UNITED STATES PATENT AND TRADEMARK OFFICE

APPLICATION NO.	FILING DATE	FIRST NAMED INVENTOR	ATTORNEY DOCKET NO.	CONFIRMATION NO.
10/813,067	03/31/2004	Steven T. Fink	244568US6YA	4640

Office Action Summary	Application No. 10/813,067	Applicant(s) FINK, STEVEN T.	
	Examiner Jeffrey Sharp	Art Unit 3677

DETAILED ACTION

US-5,332,443 to Chew

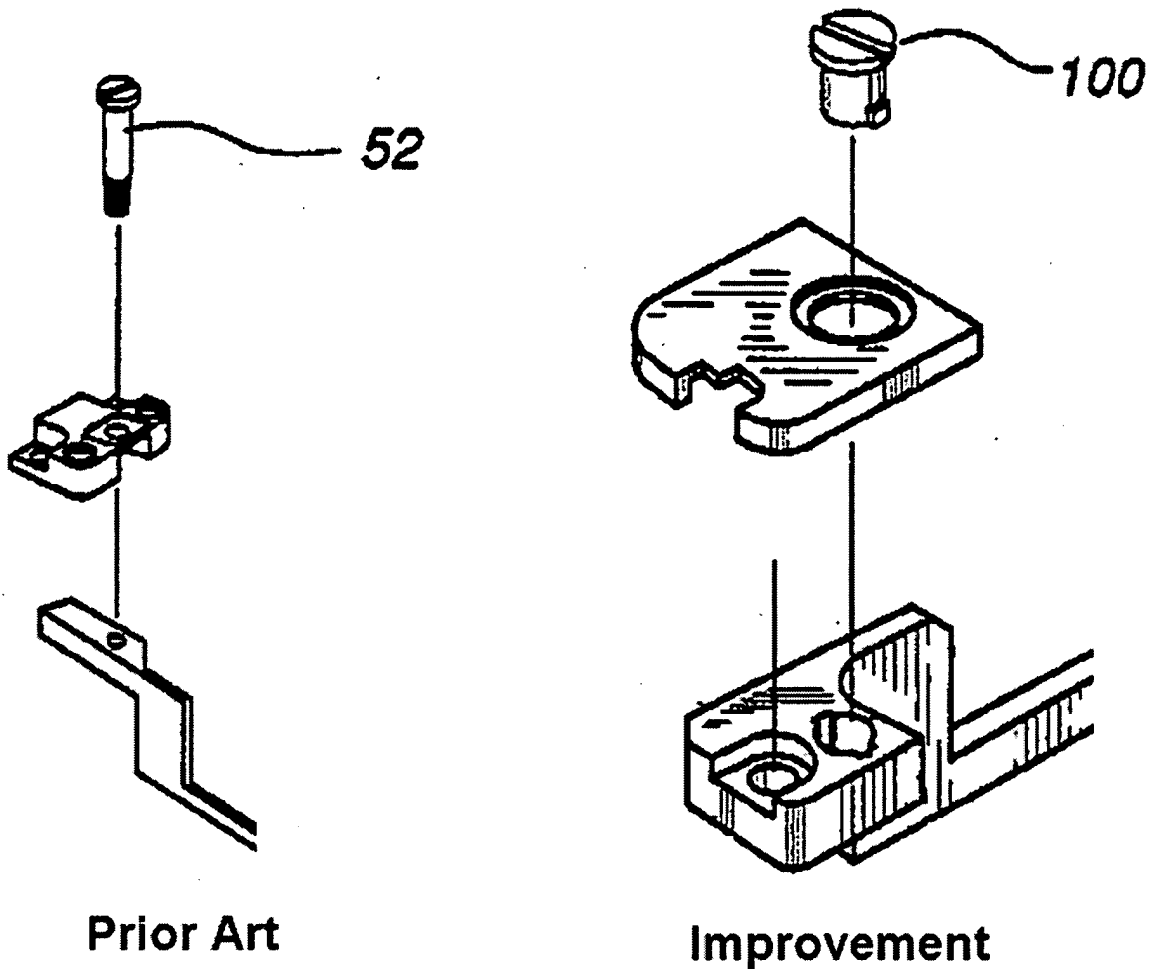
Applicant suggests that it is already known to connect a gas inject plate to an electrode plate via a bolt.

However, the prior art disclosed by Applicant fails to disclose expressly, a (quarter-turn or the like) fastener having a stem, head and a locking pin to fix a gas inject plate to an electrode plate.

Chew suggests and/or makes obvious that bolts (52) within process chambers may advantageously replace bolts with quarter-turn fasteners (100) or the like. Refer to Chew Col. 4 line 59-Col. 5 line 3, Col. 5 lines 21-33, and Col. 5 line 60-Col. 6 line 3. Chew further makes obvious that a cover plate (104) is only needed to protect those fasteners (80, 90, 82, 84, 92) not made with a resistant material (e.g., ceramic, silicon), but are instead made of metal which would *"over time oxidize and generate unwanted particles within the thermal processing chamber environment"*. Chew expressly discloses the fact that fasteners being exposed with no cover plate (e.g., quarter-turn fastener 100) are to be made from a resistant material.

Therefore, at the time of invention, it would have been obvious to one of ordinary skill in the art, to modify the prior art plasma process chamber assembly disclosed by Applicant (Figure 5), by advantageously replacing the bolt with a (broadly) quarter turn fastener or the like, in order to *"allow the [quarter-turn] screw 100, along with the cover plate 96, to be removed easily"* and to allow rapid disassembly of the two plate components.
